March 21, 2016

Subject: Comments Concerning Concentration Averaging and Encapsulation  
Branch Technical Position (81FR3166, dated January 20, 2016,  
Docket ID NRC NRC-2011-0022)

Comments Concerning Concentration Averaging and  
Encapsulation Branch Technical Position

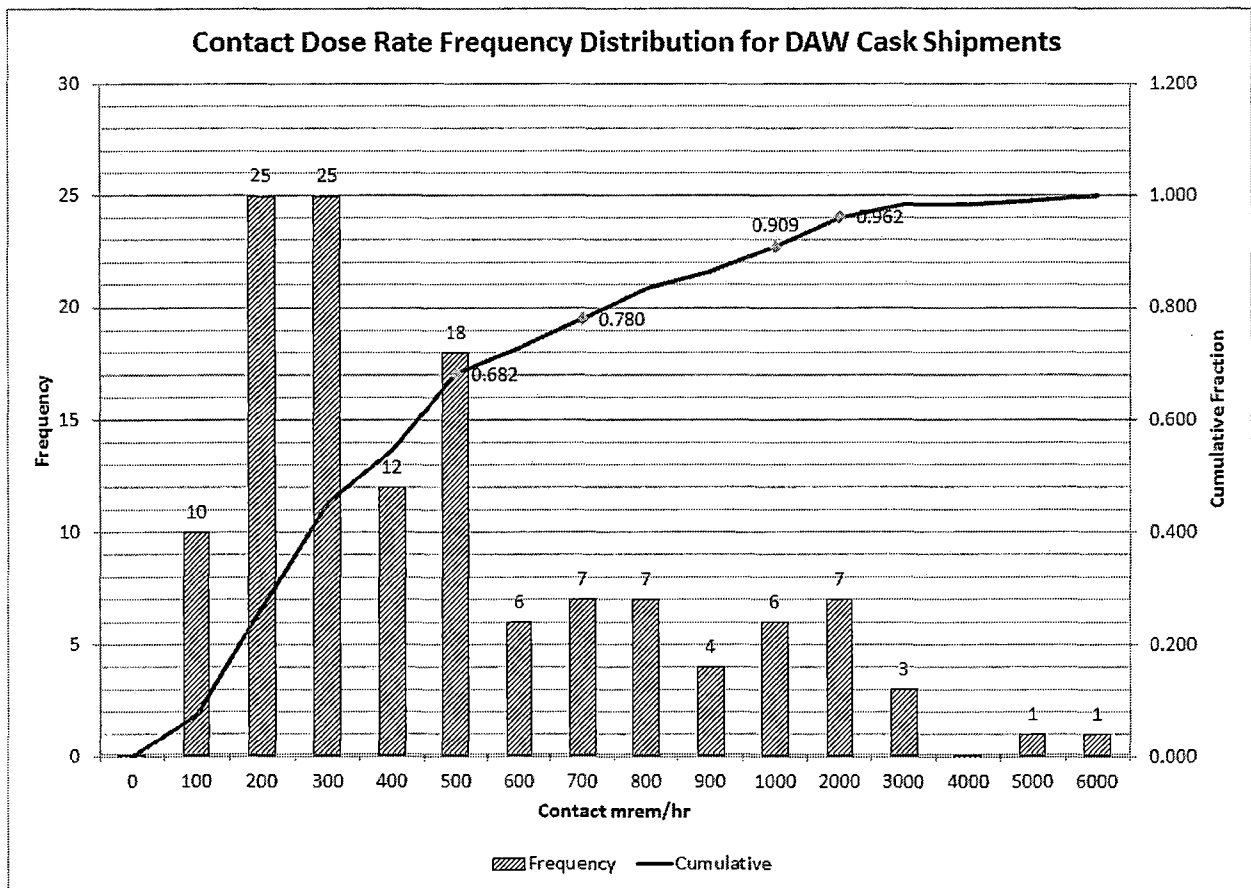
The following figure provides a distribution of contact dose rates of waste items for two different cask shipments of DAW to a waste processor. Current procedures require DAW with dose rates  $>300$  mrem/hr at 30 cm to be put in a shielded container which skews the distribution towards higher dose-rate DAW. Sites typically generate one liner of high dose-rate DAW each refueling outage ( $\sim 1/\text{yr}$ ).
